Applicant requests approval of the amendments to FIGS. 1, 4 and 9 shown in the Request for Approval of Drawing Changes being filed concurrently herewith. These changes are basically being made to clarify that FIGS. 4 and 9 show in more detail one of the complex signal paths of the front end of FIG. 1. Corresponding amendments are also being made in the written description.

VERSION TO SHOW CHANGES MADE

FIG. 1

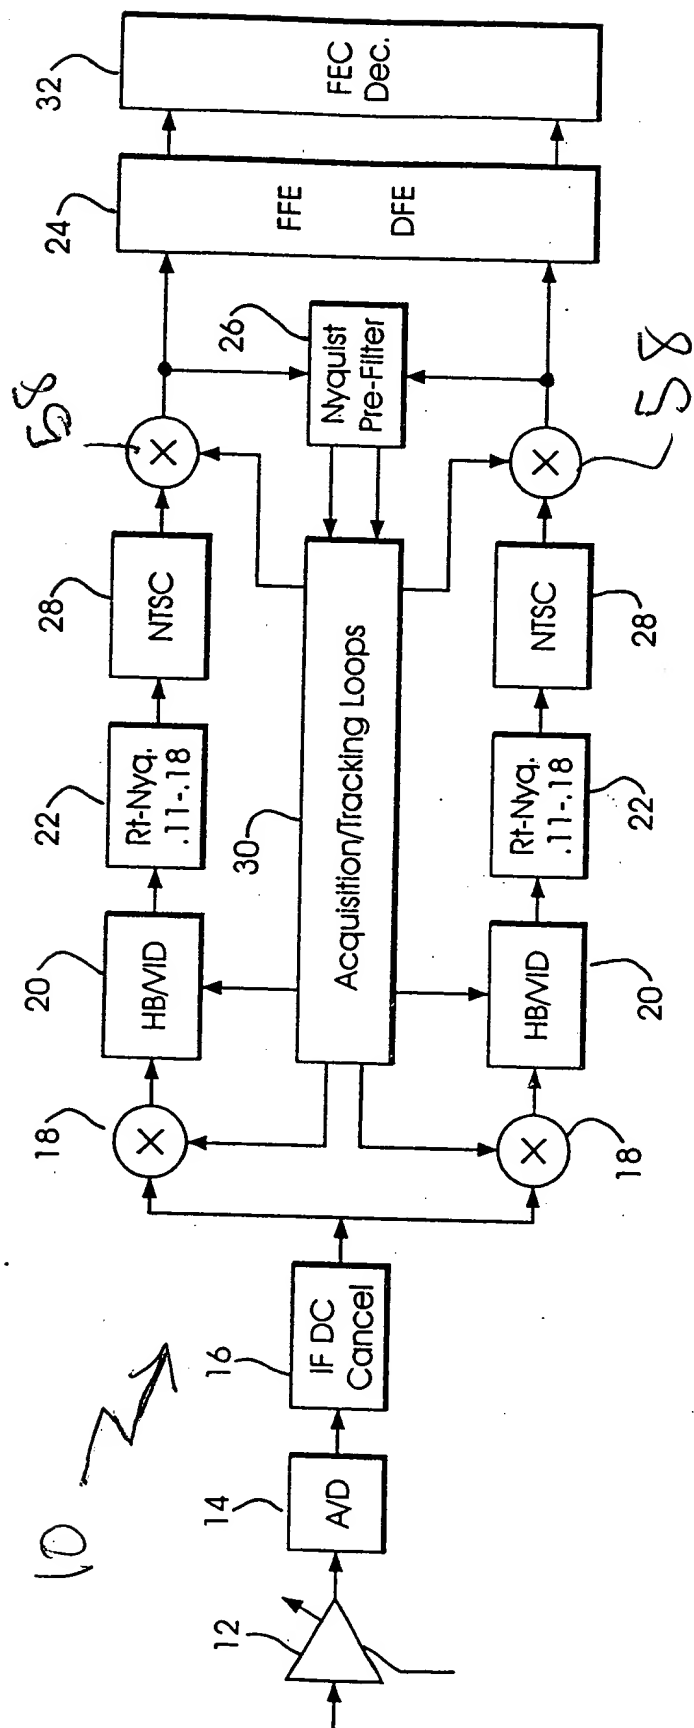
In-phase (I) and quadrature phase (Q) baseband signals are then filtered by square-root Nyquist filters 22 which can accommodate roll-off factors of 11-18%. The outputs of the square-root Nyquist filters are subsequently directed by a complex digital mixer 58 to an adaptive equalization block 24 and are parallel-processed by a Nyquist-type prefilter 26 to provide an input signal to an acquisition/tracking loop circuit 30 which includes carrier recovery loop circuitry to support carrier frequency recovery and spectrum centering as well as baud recovery loop circuitry,

for symbol timing extraction, as will be described in greater detail below. A carrier frequency recovery control signal produced by circuit 30 is applied to an input of mixer 18. A spectrum centering control signal from circuit 30 is applied to an input of mixer 58. The baud recovery control signal from circuit 30 is applied to HB/VIB 20 to sample the signal from mixer 18.

FIG. 4

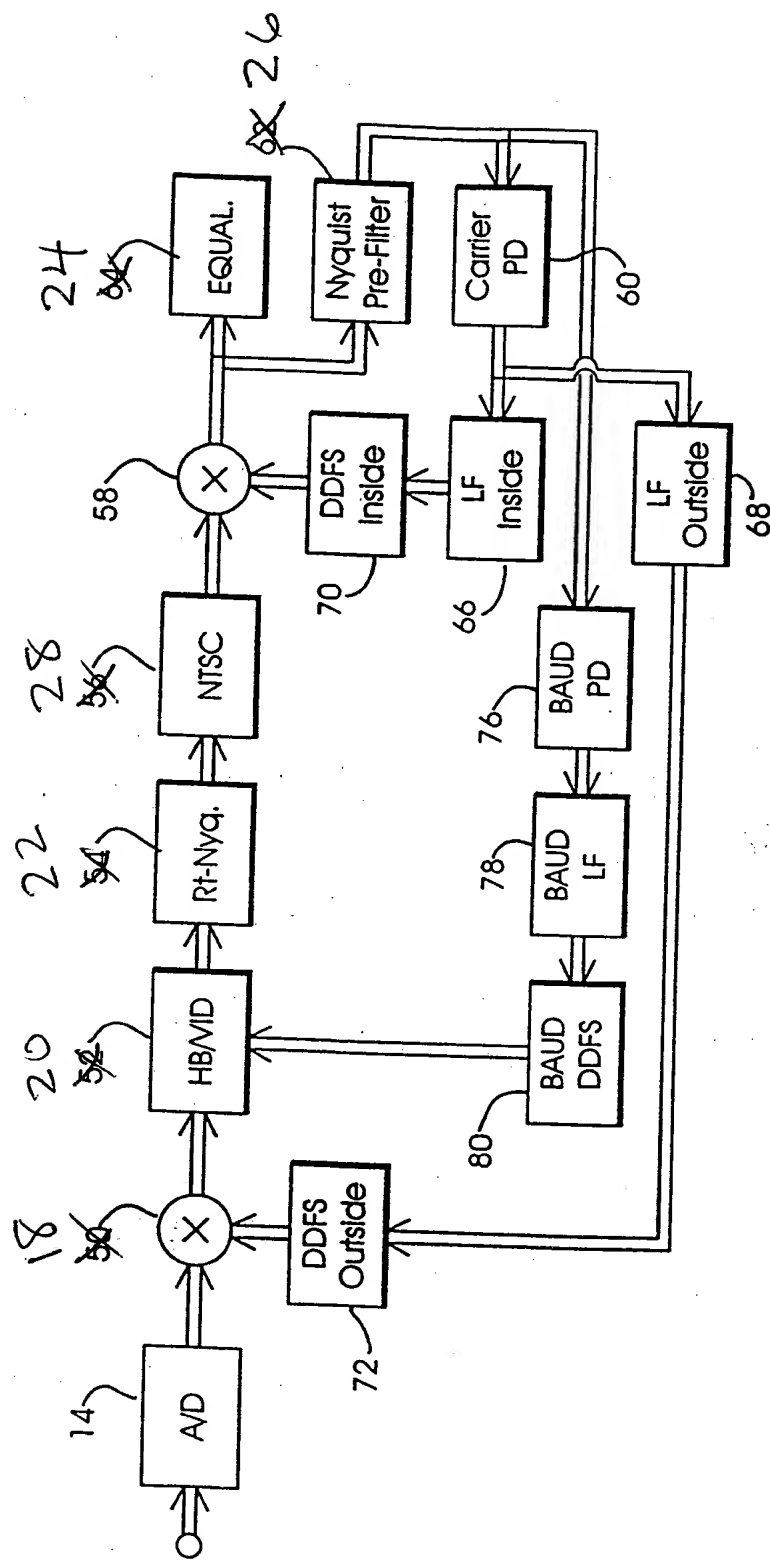
FIG. 4 is a [simplified, semi-schematic] more detailed block diagram of the architecture of [carrier recovery and baud loops of a dual mode QAM/VSF receiver in accordance with the invention] FIG. 1;

Turning now to FIG. 4, there is depicted in detail, one of the complex signal paths of the front end architecture described in FIG. 1, illustrating the acquisition/tracking loops comprising circuit 30. [in simplified, semi-schematic block diagram form, an exemplary embodiment of a unitary carrier and recovery and symbol timing loop architecture, termed] This arrangement can be regarded as "unitary" in that both functions, frequency acquisition and tracking and symbol timing (also termed "baud recovery") are operable in response to the pilot (unsuppressed carrier) signal. In the embodiment of FIG. 4, an input IF spectrum is digitized by an analog-to-digital converter (A/D) and the resulting digital complex signal is directed to a complex mixer 50 where it is combined with a complex signal having a characteristic frequency  $f_C$  equal to the carrier frequency. The resulting complex signal is processed by a highband filter and variable rate interpolator, represented as a single processing block in the embodiment of FIG. 4, and denoted HB/VID 52. In a manner to be described in greater detail below, symbol timing is performed by a baud loop coupled to provide symbol timing information to the variable rate interpolator (VID) portion of the HB/VID filter 52. Following interpolation, baseband IF signals are processed by a square root Nyquist filter which has a programmable roll off  $\alpha$  of from about 11 to about 18%. The square root Nyquist filter 54 is further designed to have a particular cutoff frequency that has a specific relationship to the VSB pilot frequency  $f_C$ , when the VSB spectrum centers at DC. In a manner to be described in greater detail below, this particular cutoff frequency is chosen to have this particular relationship in order that both carrier recovery and symbol timing recovery might be based on a VSB pilot frequency enhancement methodology.

FIG. 9

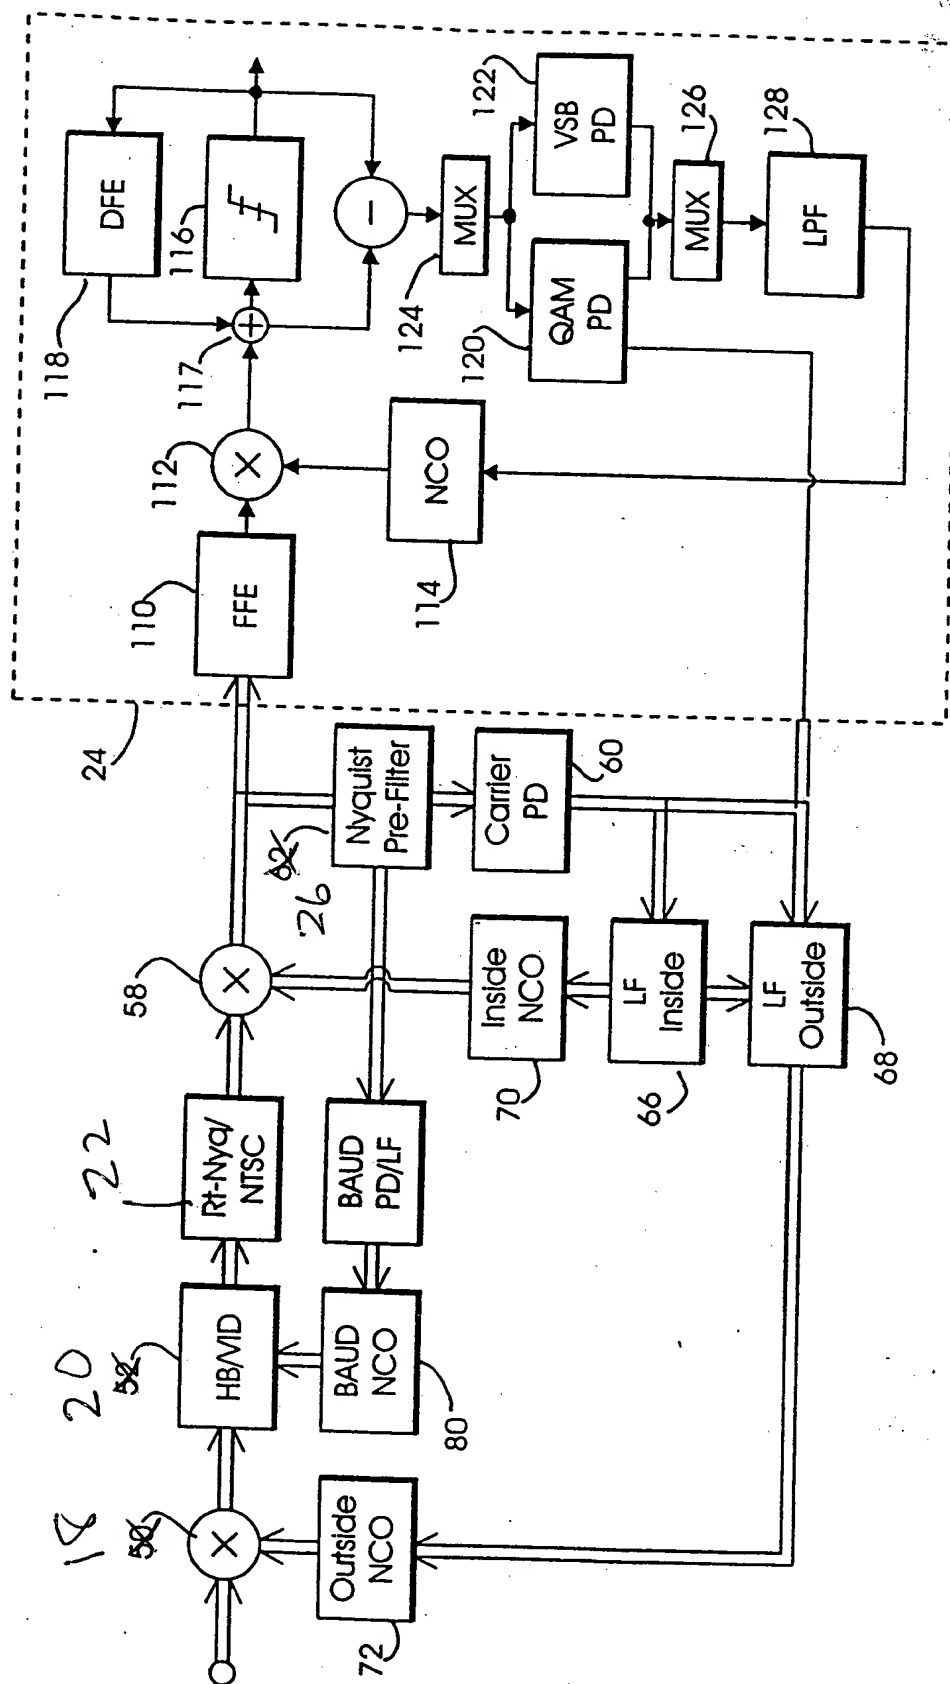
FIG. 9 is a simplified, semi-schematic block diagram of a dual mode QAM/VSF receiver architecture, including the decision directed carrier phase tracking circuitry [in accordance with the invention] of FIG. 4;

Turning now to FIG. 9, there is depicted a simplified, semi-schematic block level diagram of one of the complex signal paths of the front end of FIG. 4 incorporated in a dual mode baseband architecture. [of the exemplary] A dual mode QAM/VSB receiver, [including] includes details of the construction and arrangement of adaptive equalizer 24 having decision directed VSB phase tracking and decision directed QAM frequency acquisition and phase tracking loops in accordance with the present invention. As illustrated in the embodiment of FIG. 9, the adaptive equalizer includes a feedforward (FFE) block 110 configured to receive symbol aligned complex signals centered in baseband. The FFE 110 is suitably constructed as either a 64-tap real FFE, for VSB applications, or a 16-tap complex FFE when used in connection with QAM modulated signals. Carrier phase alignment and/or carrier frequency/phase alignment is performed in a mixer 112 which receives signals from the FFE 110 and combines them with a timing reference signal developed by a timing reference circuit 114 such as a numerically controlled oscillator (NCO) a voltage controlled oscillator (VCO) or a direct digital frequency synthesizer (DDDFS). Timed signals are then provided to a slicer 116 operating in conjunction with a decision feedback (DFE) block 118 which, in combination, provide hard decision information on constellation states as well as error information relating to differences between actual signal trajectory relative to an ideal signal trajectory.
